1 SD Site Plan Expanded
1/64" = 1'-0"

① SD Site Plan
1/32" = 1'-0"

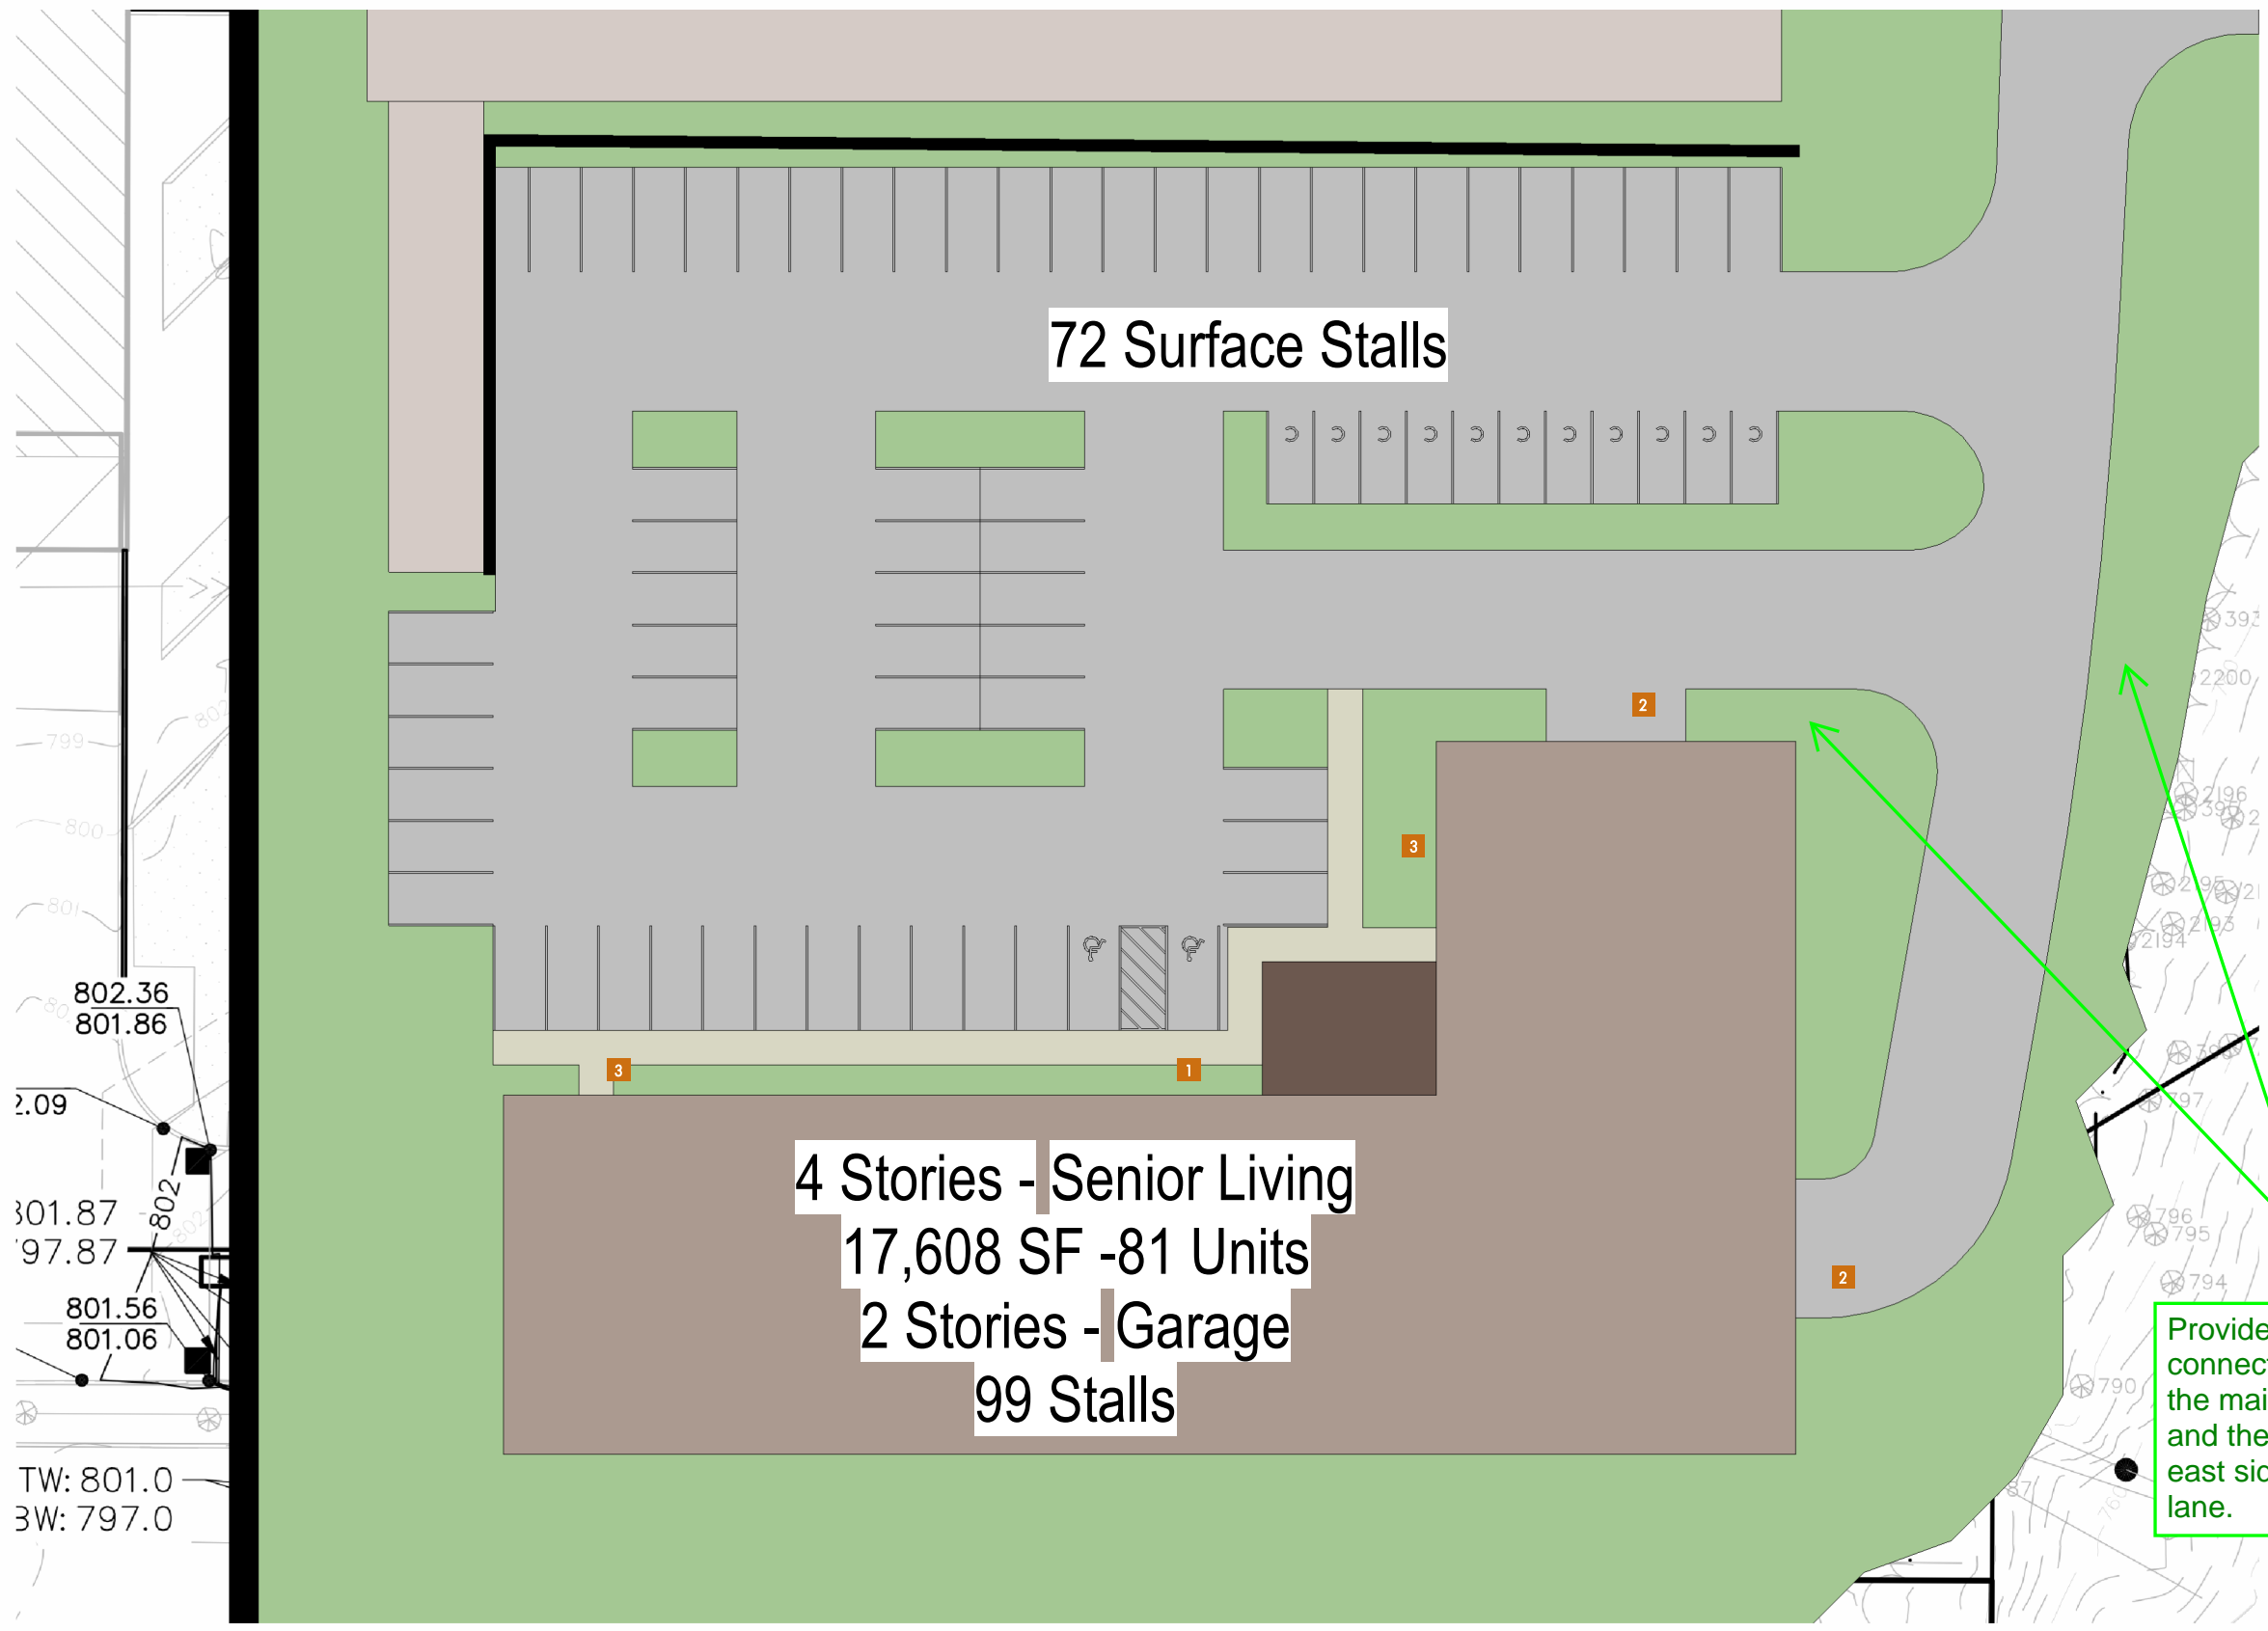
Provide updated private common access and parking agreement and common utility agreement.

How will tenants, both residential and office, know where to park (and where not to)?

Hydrant coverage shall be provided within 50' of the FDC and within 150' of all portions of the structure.

Emergency responder radio coverage meeting the requirements of appendix P in the 2020 MSFC shall be provided throughout the property and within the structures.

Building/property shall be adequately signed for emergency response.

Ensure landscaping doesn't interfere with access to the building, hydrants and/or FDC.

Provide a sidewalk connection between the main entrance and the trail on the east side of the drive lane.

② Level -1
1" = 30'-0"

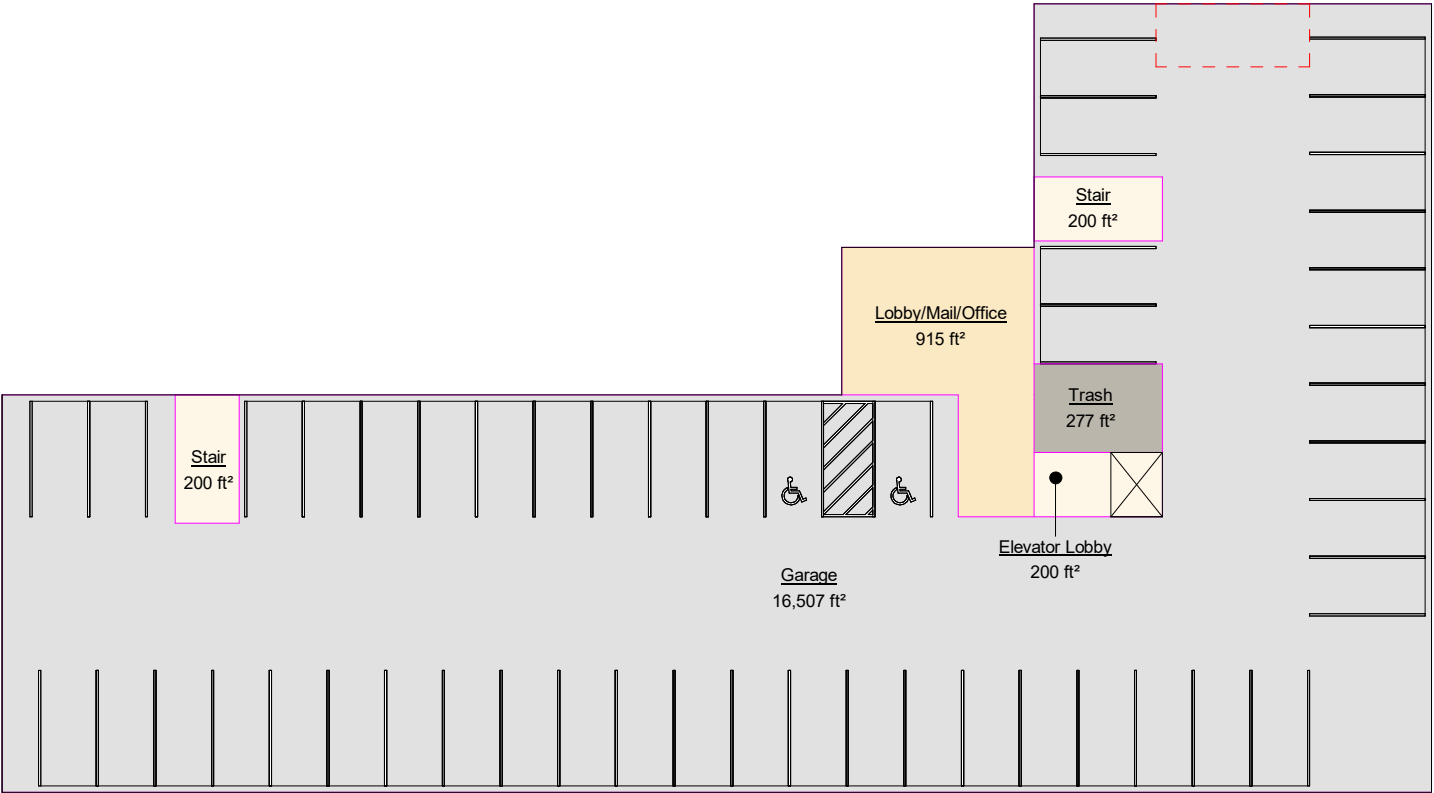
Building plans must
be signed by a MN
licensed architect.

SAC review by MET council will be required.

On January 2nd, 2025, the City of Bloomington implemented a City SAC charge. The cost will be \$2,026 per City SAC unit. The amount of SAC charged will mirror the MET Council Determination. This applies to any permits submitted on or after 01/02/25.

When plans are 80% complete please contact Building & Inspections to set up a Building Code review.

Provide a detailed code analysis with the plans.

2 Level 4
1" = 30'-0"

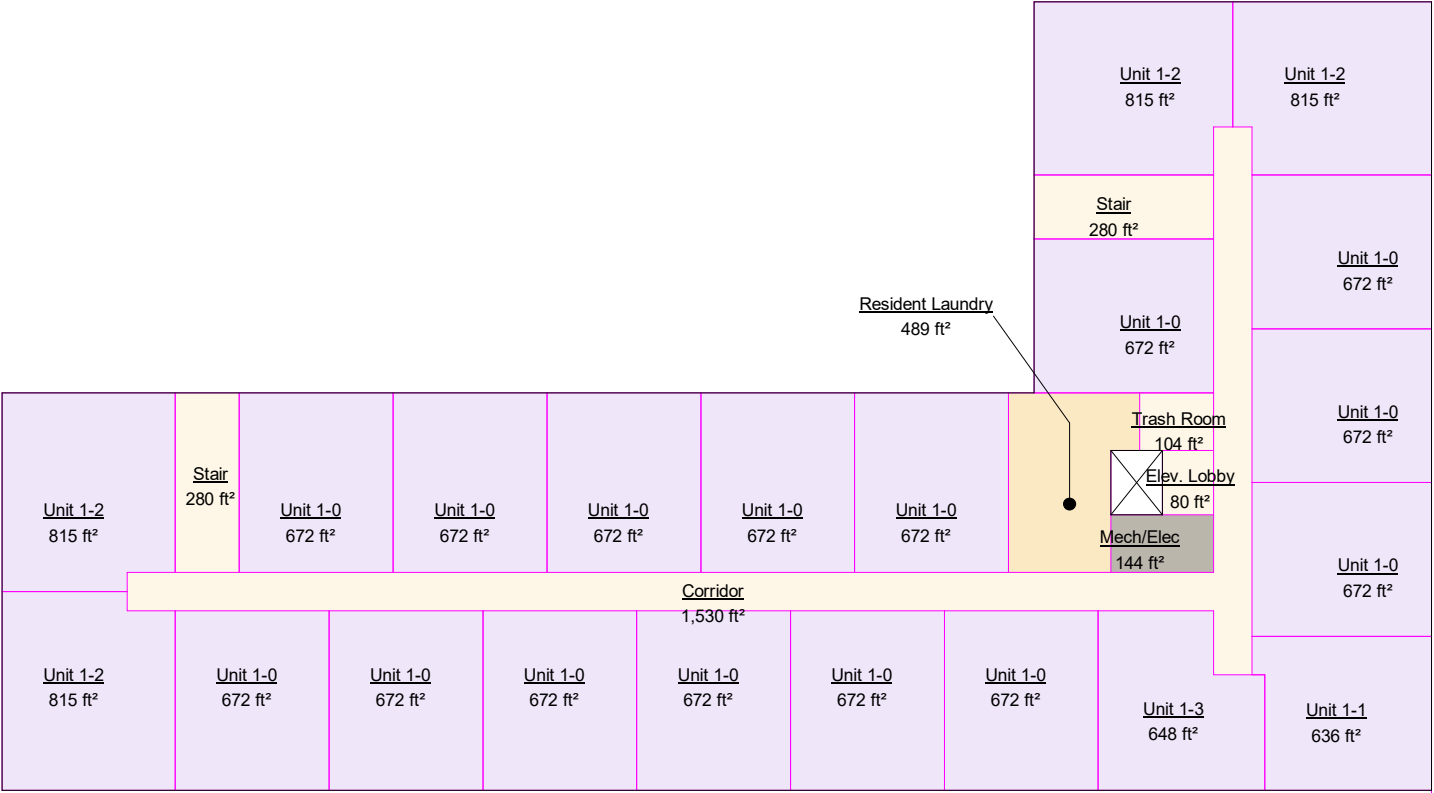
Senior housing is not subject to the storage unit requirement. That said, City Code does require adequate in-unit storage space. It may be prudent to incorporate storage units anyway.
